APPENDIX 9

OZS-2020-0024 – RESULTS OF APPLICATION CIRCULATION

Re: Application for Site Plan Approval – 0 Mayfield Road - COB File: OZS-2020-0024

Re: Zoning By-law Amendment Application (Temporary Use) – OZS-2020-0024
0 Mayfield road
Lot 17, Concession 11, E.H.S.
City of Brampton
2538948 Ontario Inc. (Agent: Blackthorn Development Corp.)

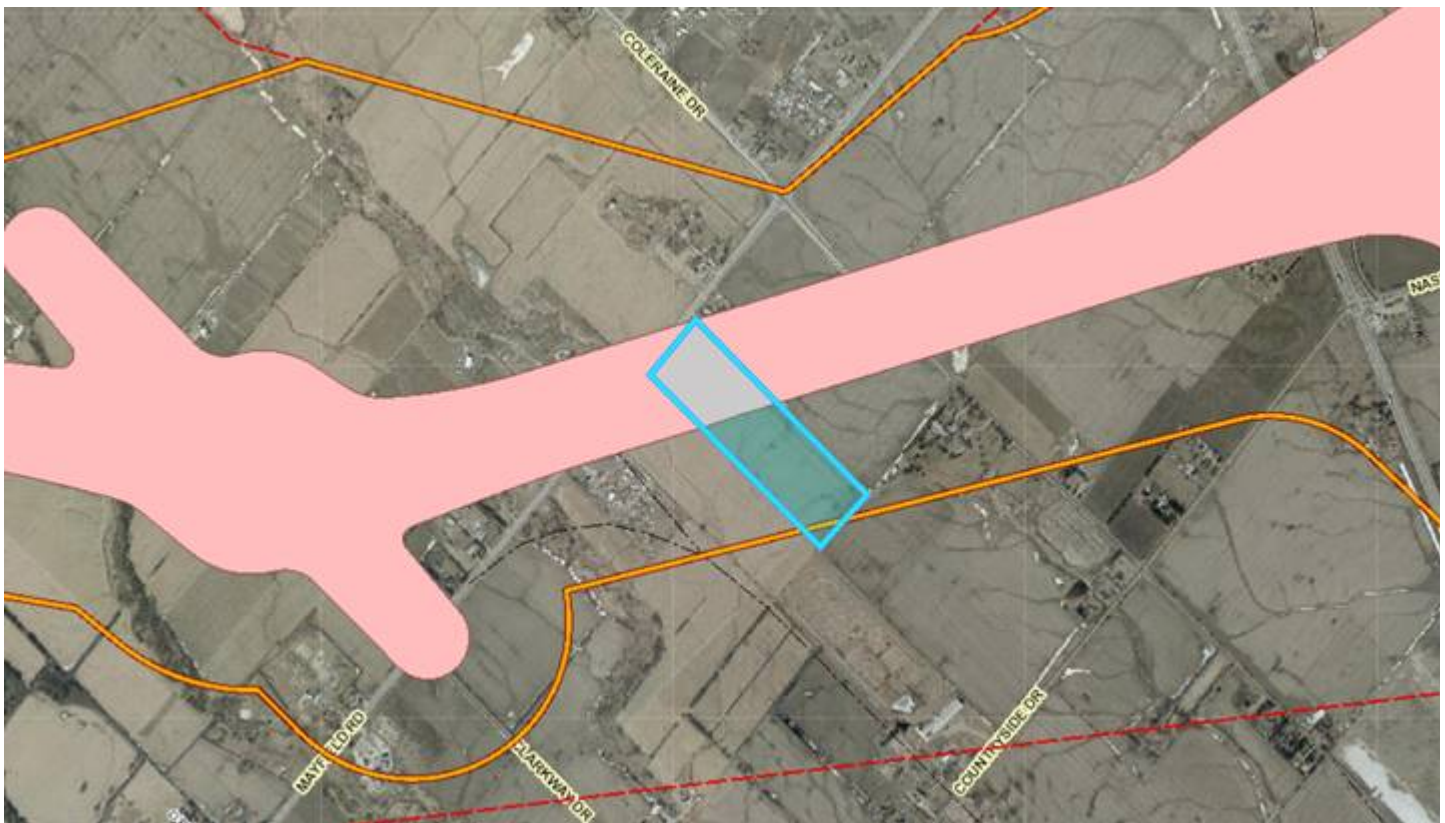
- This property is located partially within the GTA West Preferred Route and the 2020 Focused Analysis Area (FAA) and is still subject to the outcome of the study. See map below.
- It is recommended that approval contain condition wherein the owner would acknowledge that a portion of the lands may be required for the Provincial transportation corridor and the evaluation of the value of the land will be based on the permitted uses of the land prior to the temporary use by-law being enacted.
- We recommend that the temporary use permissions be provided for not more than three years and advise the property owner against making substantial improvements to the property during this period of time.
